101 GRADING & PLOT PLAN

PLOT PLAN & DETAILS FOR HANGAR-OFFICE BUILDING
ADDISON AIRPORT, ADDISON, TEXAS

The Town of Addison has reviewed your building plans and issued a building permit with the understanding that the items checked below, as well as noted elsewhere on the plans, are to be complied with or corrected. The items checked on this list were either shown incorrectly on the plans or were not shown in sufficient detail on the plans. Unless otherwise noted, all questions should be directed to the Building Inspection Department.

SECOND FLOOR PLAN
FOR HANGAR-OFFICE BUILDING
ADDISON AIRPORT, ADDISON, TEXAS

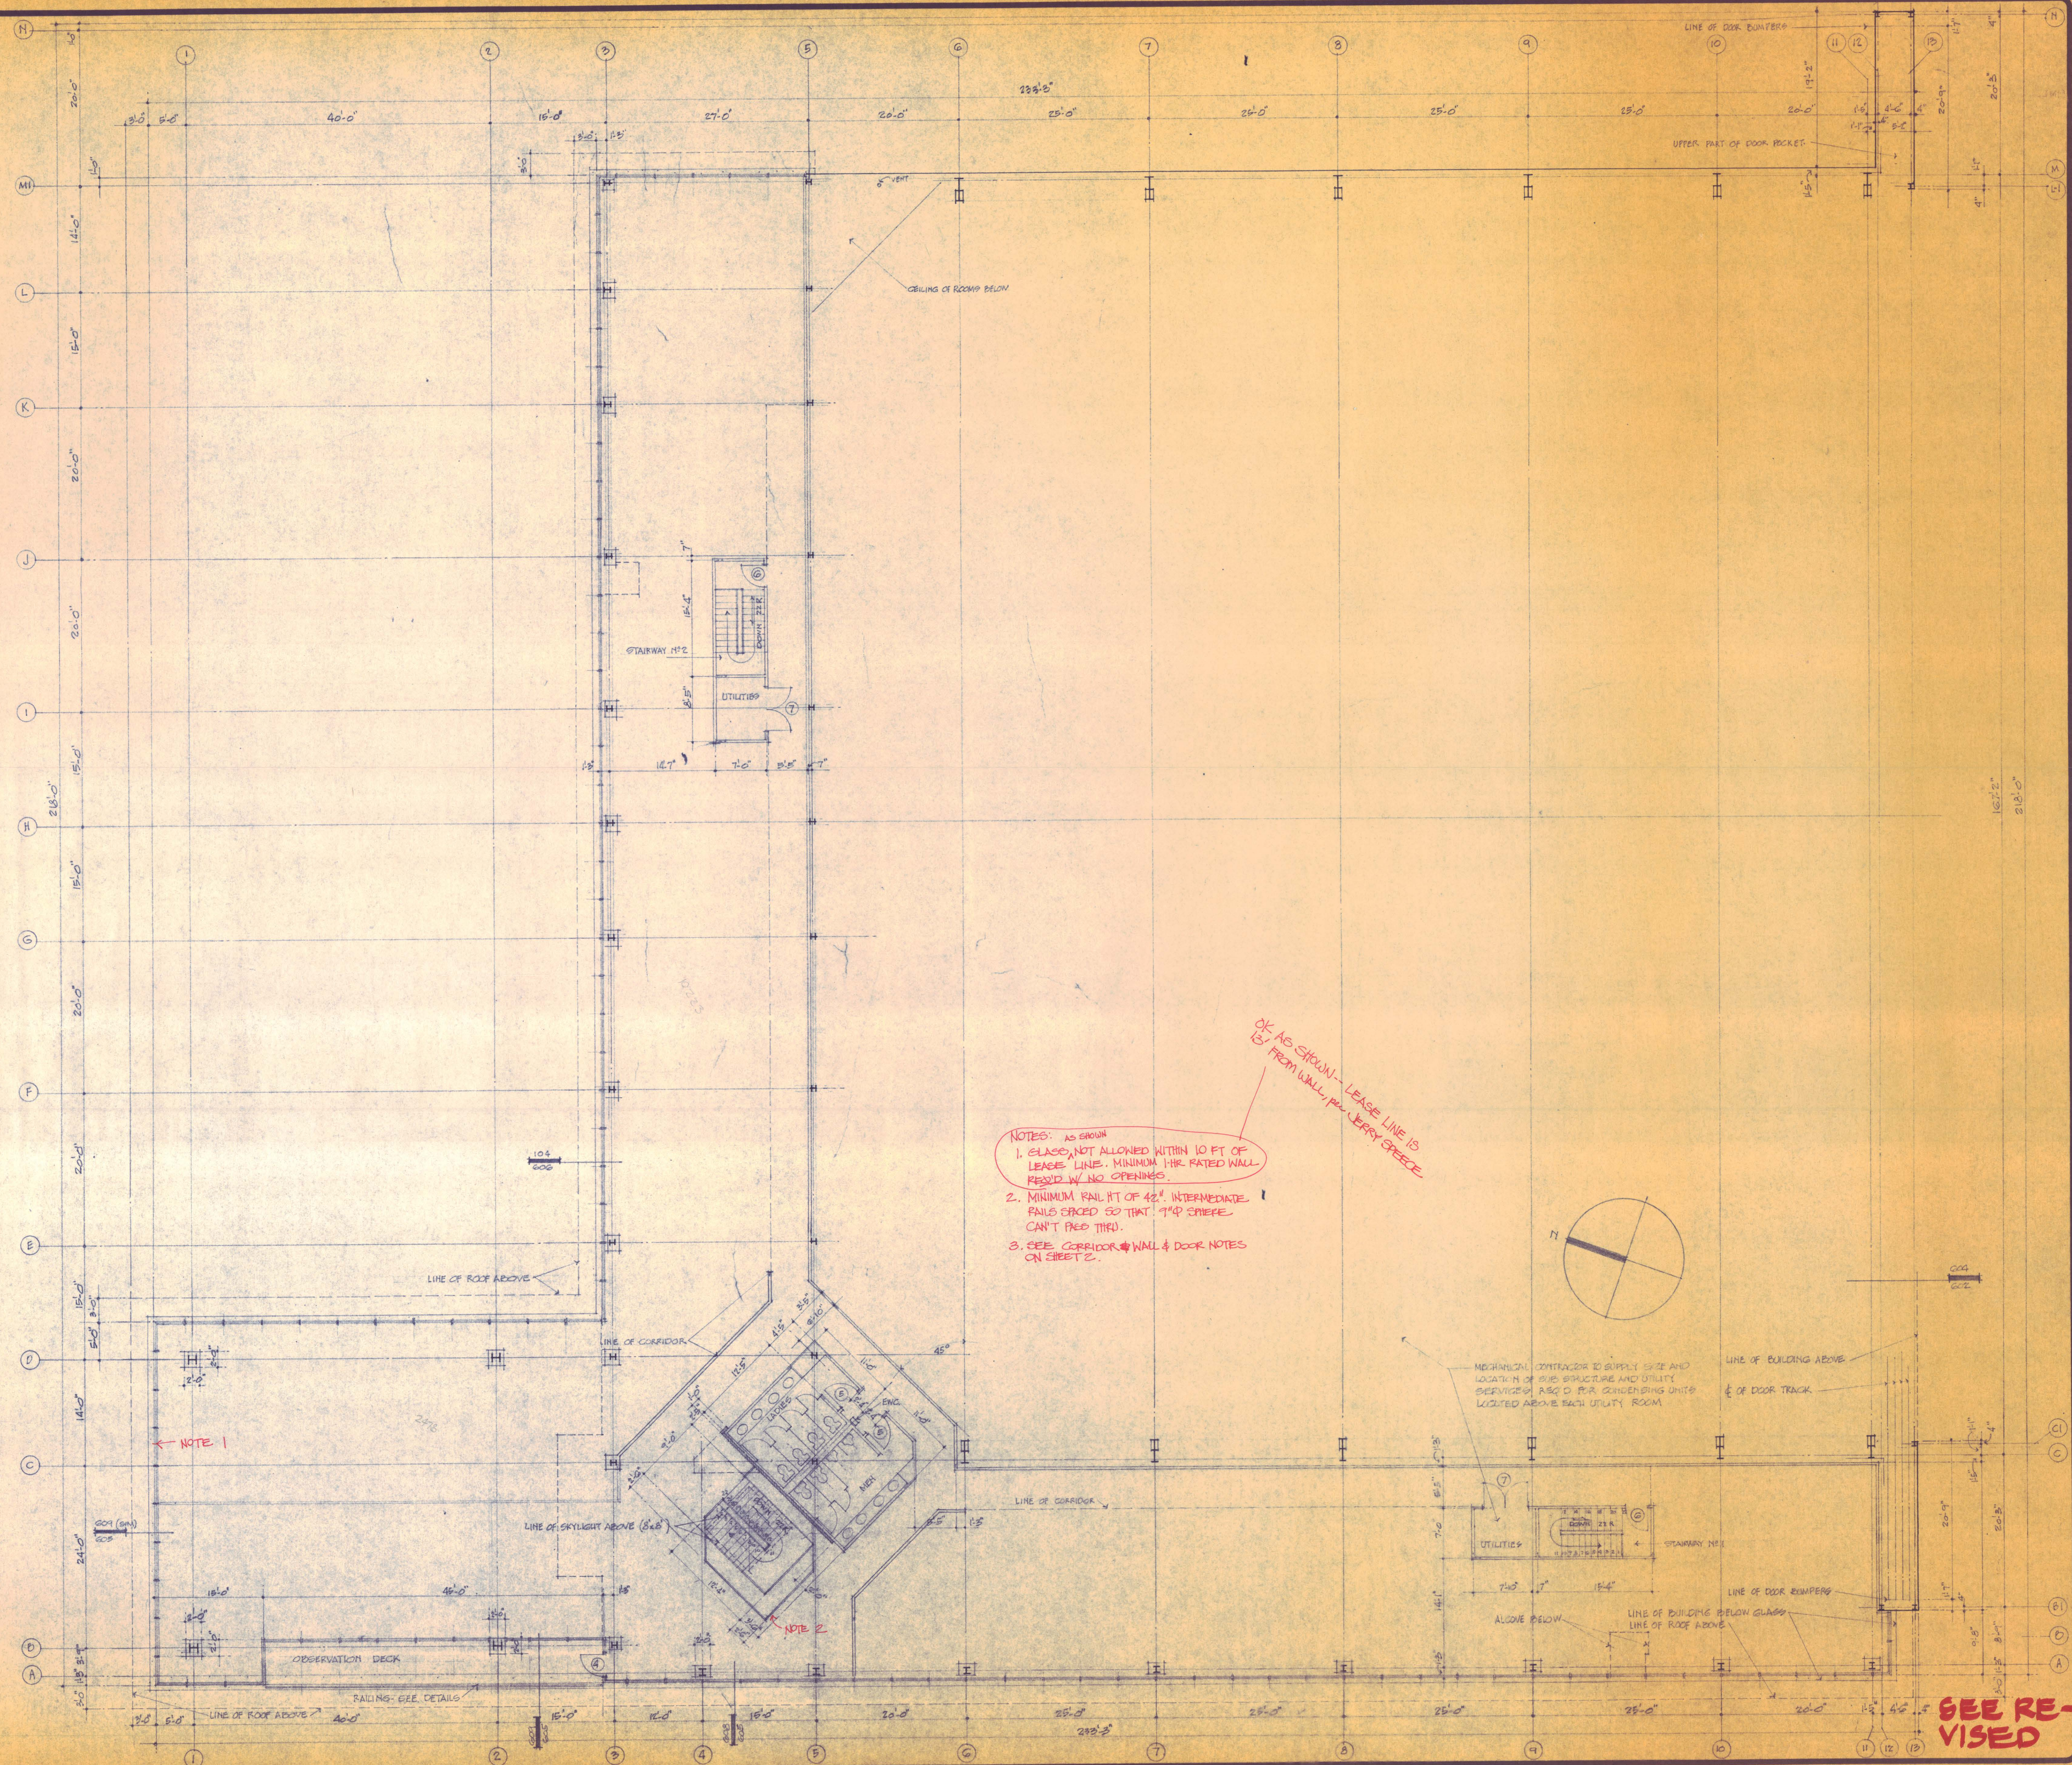
- NOTES: AS SHOWN
1. GLASS NOT ALLOWED WITHIN 10 FT OF LEASE LINE. MINIMUM 1HR RATED WALL REQUIRED W/ NO OPENINGS.
 2. MINIMUM RAIL HT OF 42". INTERMEDIATE RAILS SPACED SO THAT 9"Ø SNEEZE CAN'T PEEF THRU.
 3. SEE CORRIDOR WALL & DOOR NOTES ON SHEET 2.

NOTE 1

NOTE 2

OK AS SHOWN - LEASE LINE IS 15' FROM WALL PER JERRY SPEECE

611 PLUMBING RISER DIAGRAM

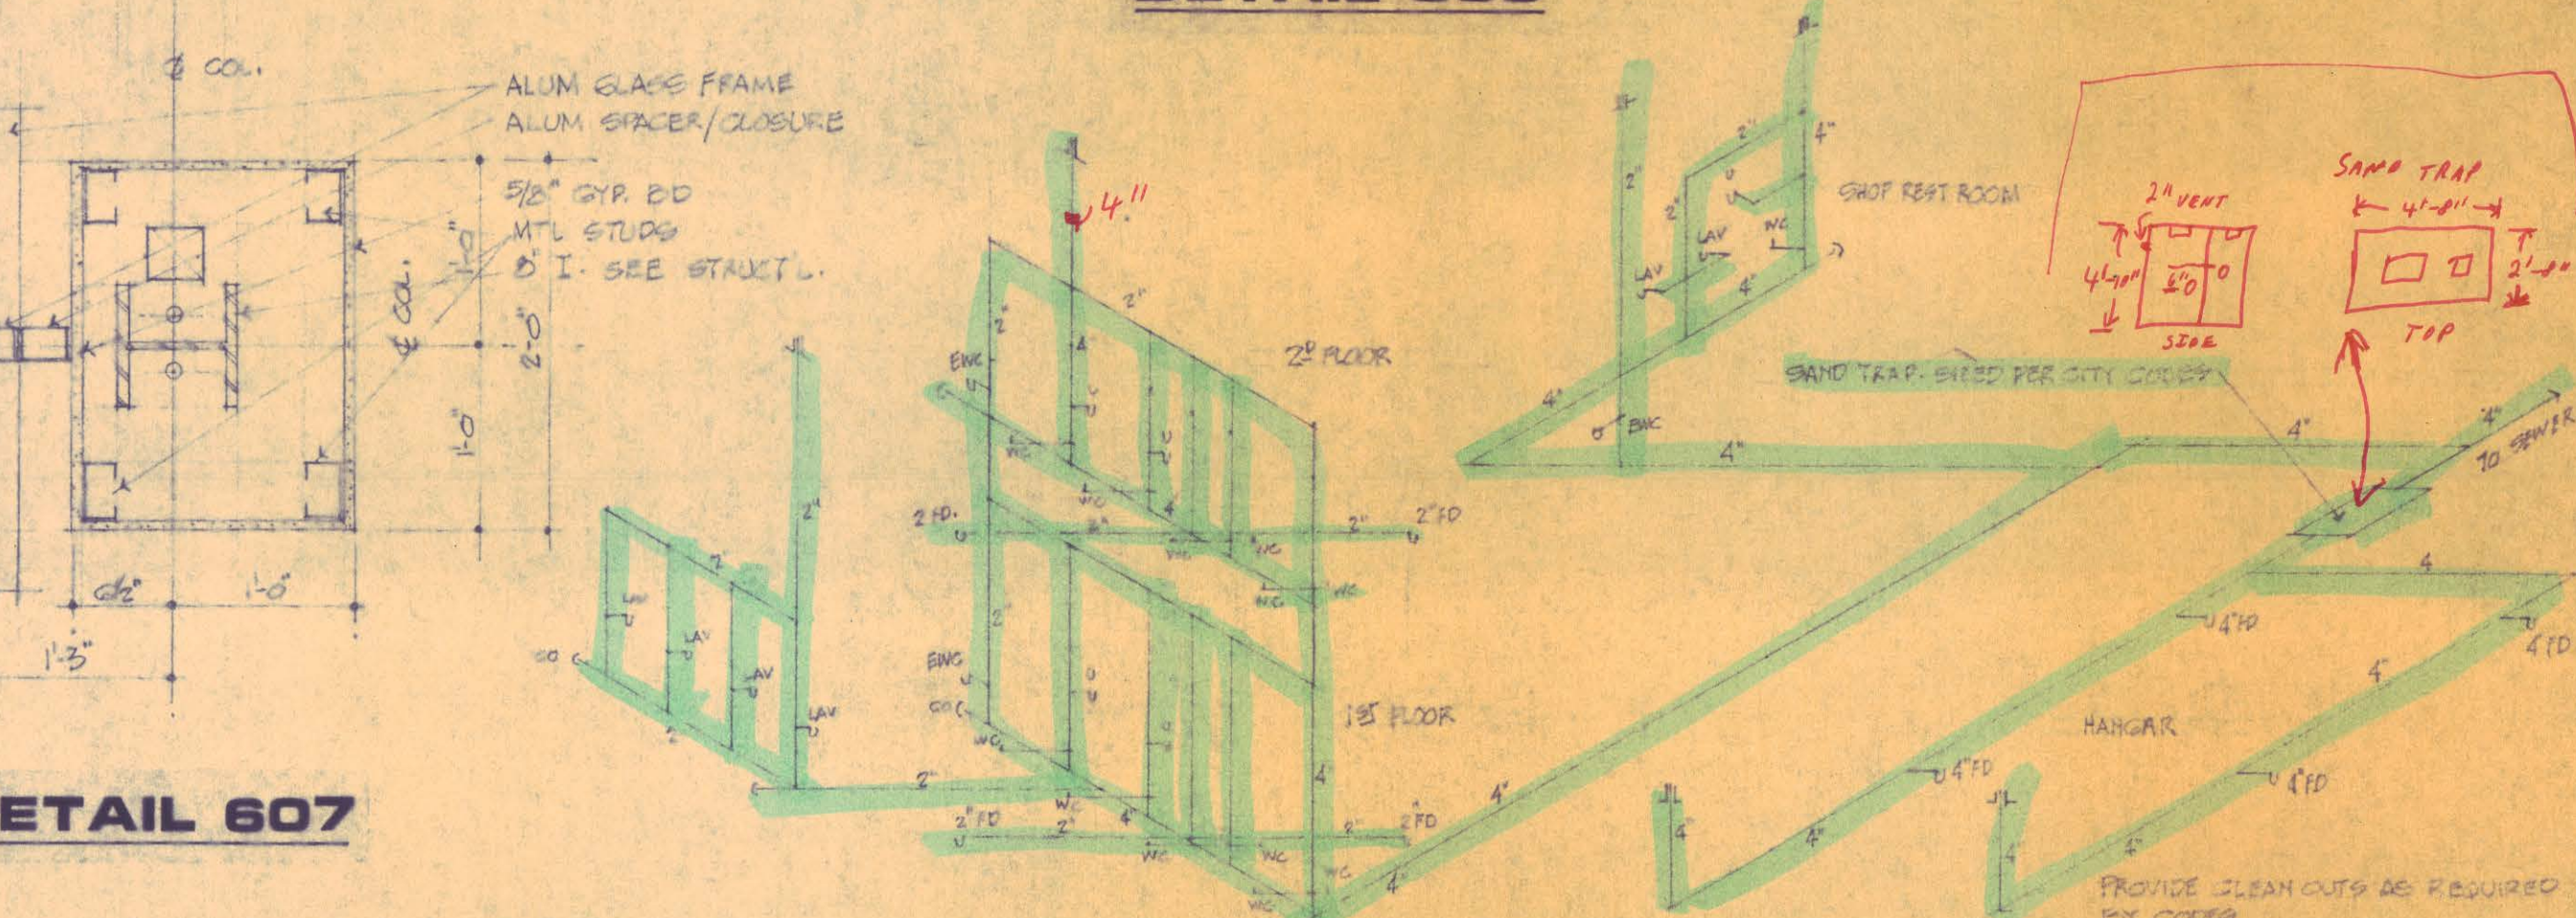
NO PVC ALLOWED
